Economic Commission for Europe**Inland Transport Committee****World Forum for Harmonization of Vehicle Regulations****Working Party on General Safety Provisions****127th session**

Geneva, 15–19 April 2024

Amendments to Regulations on Gas-Fuelled Vehicles:**UN Regulation No. 110 (Compressed Natural Gas and Liquefied Natural Gas vehicles)****Proposal for Supplement 8 to the 01 Series of Amendments to
UN Regulation No. 110 (Compressed Natural Gas and
Liquefied Natural Gas vehicles)****Submitted by the expert from the European Association of Automotive
Suppliers ***

Example 2

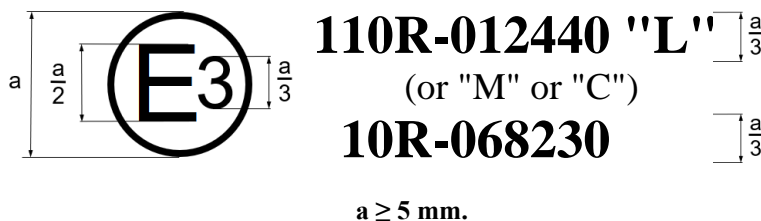
"7.4.3. If the component conforms to a component type approved under one or more other UN Regulations, and if the country which has granted the different approvals is the same, the symbol prescribed in paragraph 7.4.1. above need not be repeated for that specific country; in such a case, the Regulation and approval numbers and the additional symbols of all the Regulations under which approval has been granted by the same country shall be placed in rows to the right of the symbol prescribed in paragraph 7.4.1. above."

This approval mark when affixed to the CNG and or LNG component shows that this component has been approved in Italy (E 3), pursuant to UN Regulation No. 110 under approval number 012440 and pursuant to UN Regulation No. 10 under approval number 068230. The first two digits of the first approval number indicate that the approval was granted in accordance with the requirements of UN Regulation No. 110 as amended by the 01 series of amendments.

The first two digits of the second approval number indicate that the approval was granted in accordance with the requirements of UN Regulation No. 10 as amended by the 06 series of amendments.
